Public Comment from Adam Theisen

RC1

RC2

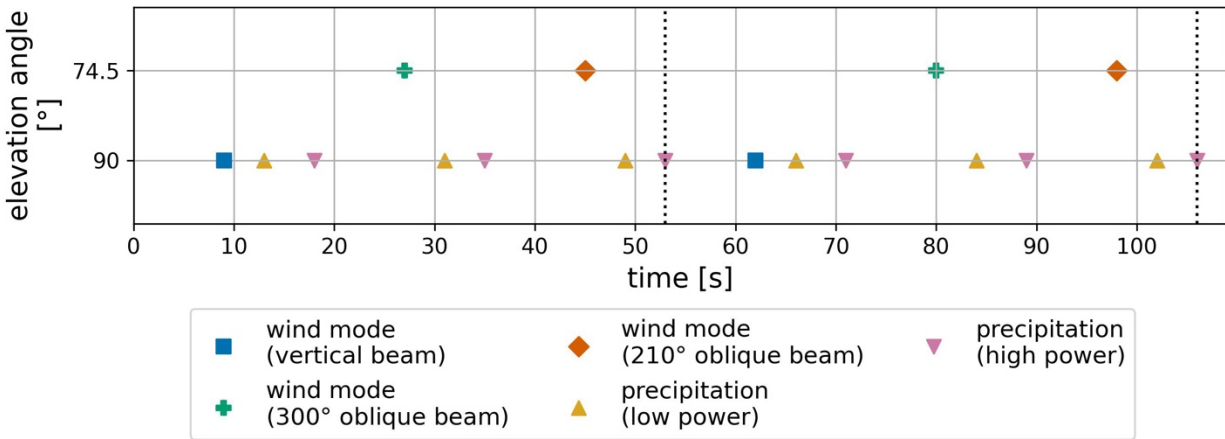
11. Line 109. The full cycle time of approximately 53 seconds does not match the times listed in Table 1. In Table 1, the wind, long pulse, and short pulse modes require 27.6 seconds (3x9.2 seconds), 4.5 and 4 seconds, respectively. This adds up to less than 37 seconds. The text in the manuscript needs to match the values in the tables.

This is because both precipitation beams are repeated between each wind beam. For one

period, the order is: wind (vertical), precip. short pulse, precip. long pulse, wind (300° oblique beam), precip. short pulse, precip. long pulse, wind (210° oblique beam), short pulse, precip. long pulse. These dwell times add up to 53 seconds for a full cycle. Because this is a bit confusing to read, we have added a new figure to the text visualizing this cycle, which is also included here:

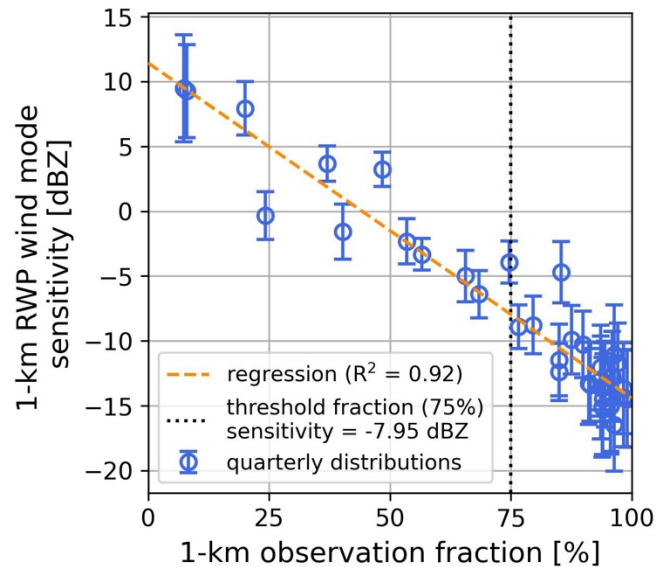
Lines 299-300: Explain how you determined this -7.5 dBZ threshold.

Thank you for the comment. We have rewritten this section, added a new figure, and refined this methodology. Previously, this was based on qualitative analysis of the profiles and matching where the radar observations started to look bad with the measured minimum detectable reflectivity (former “sensitivity”). Unfortunately, this is not exactly a well-described metric or replicable process! So, we altered this section to be more statistically rigorous.

Essentially, this all is motivated by the need for a “cut-off point” in the data since the sensitivity diminishes gradually during the time period. When a RWP is performing optimally it should retain – in contrast with hydrometeor-oriented radar (such as KAZR) – consistent valid observations at low altitudes throughout the day, as clear-air motions should be sensed more-or-less continuously. Therefore, we can infer that periods with consistently low observation counts at low altitudes are more likely to be the result of missing data from degraded sensitivity and are, consequently, not a robust representation of the day’s weather. However, gating data purely on average observation frequency has its own issues. For example, one may imagine a period that recorded fewer average observations due to a higher-than-average frequency of low clouds, impeding observations above.

With this in mind, we regress our derived quarterly 1-km wind mode minimum detectable reflectivity (formerly “Sensitivity”, from Figure 6 in the original submitted manuscript) on 1-km observation fraction. We define this new metric as the fraction of the day for which observations are recorded at 1 km, with 100% being equivalent to constant observations all day and 0% being equivalent to no valid observations all day. These results are shown in the figure below, now added to the manuscript:

With an R^2 of 0.92, we find that the averaged 1-km minimum detectable reflectivity explains the overwhelming majority of the variance of missing data in this climatology. Based on this information, we set a threshold of RWP sensitivity at -7.95 dBZ (black dotted line in this figure), which corresponds to 75% observation fraction. Admittedly, this 75% threshold is an arbitrary

value based on the idea that it would be best to have at least 75% daily representation when deriving climatological statistics. Through this threshold, 39 months of data are removed.
